Doc name	Comment	Visual, if any
GE01-CAS-0003-FL6-L1-C01	<p>Do we design concrete walls for security office? If yes, I would suggest considering glass walls to enable security team to have native visual access to the DC. I would also suggest to move security office next to the DC entrance.</p>	
GE01-CAS-0003-FL6-L1-C01	<p>We assume that there will be visitors/guest to our DC. I recommend to consider locker for personal belongings. That is one of the security requirements. I have highlighted area as potential space for locker</p>	
GE01-CAS-0003-FL6-L1-C01	<p>I recommend to have our space in DC. We can keep mission critical tools. E.g. We understand that we have redundant cooling system, but I would recommend to have also mobile fan for the disaster case and decreasing temperature in room (-s) with mission customer IT hardware</p>	
GE01-CAS-0003-FL6-L1-C01	<p>If we consider fire suppression system, e.g. FM-200, I recommend having separated cabinet for to keep balloons</p>

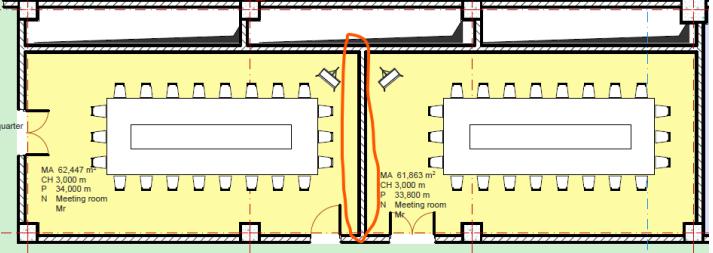
GE01-CAS-0003-FL6-L1-C01	<p>I don't see CCTV points on the map. Is there any risk if we submit doc for UI Tier III design and then decide on CCTV design?</p>	
GE01-CAS-0003-FL7-L2-C01	<p>I would suggest putting Lego wall if space needs to be increase for more guests, e.g. company townhalls.</p>
